Service Information Bulletin

SUBJECT	DATE
SPN 521221 (TCM)	April 2017

Publication Number / Title	Platform	Section Title	Change
DDC-SVC-MAN-0140	DT12 Transmission	SPN 521221/FMI 19	This procedure has been rewritten.

45801

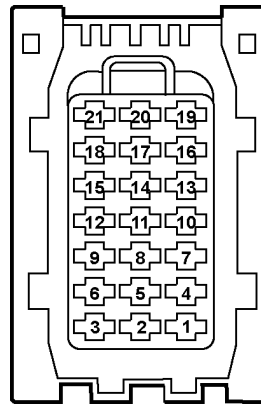
1. Are there any battery voltage faults (SPN 168/FMI any)?
 - a. Yes; troubleshoot battery voltage faults first.
 - b. No; Go to step 2.
2. Has the Transmission Control Module (TCM), Motor Control Module (MCM), Aftertreatment Control Module (ACM), or Common Powertrain Controller (CPC) been recently reprogrammed?
 - a. Yes; clear the fault codes. If the fault does not become active, release vehicle. If fault becomes active, Go to step 3.
 - b. No; clear the fault codes. If the fault does not become active, release vehicle. If fault becomes active, Go to step 3.
3. Disconnect the TCM X1 21-pin connector.
4. Inspect TCM X1 21-pin connector for corrosion, water intrusion or pin damage. Are there any damaged pins?
 - a. Yes; repair as necessary.
 - b. No; Go to step 5.
5. Turn the ignition ON (key ON, engine OFF).

6. Measure the voltage between TCM X1 21-pin connector pins 1, 2, 3, 4, 6 (ignition/battery voltage), and ground. Is the voltage less than 11.5 volts?
 - a. Yes; restore voltage to TCM X1 21-pin connector pins 1, 2, 3, 4, and 6.
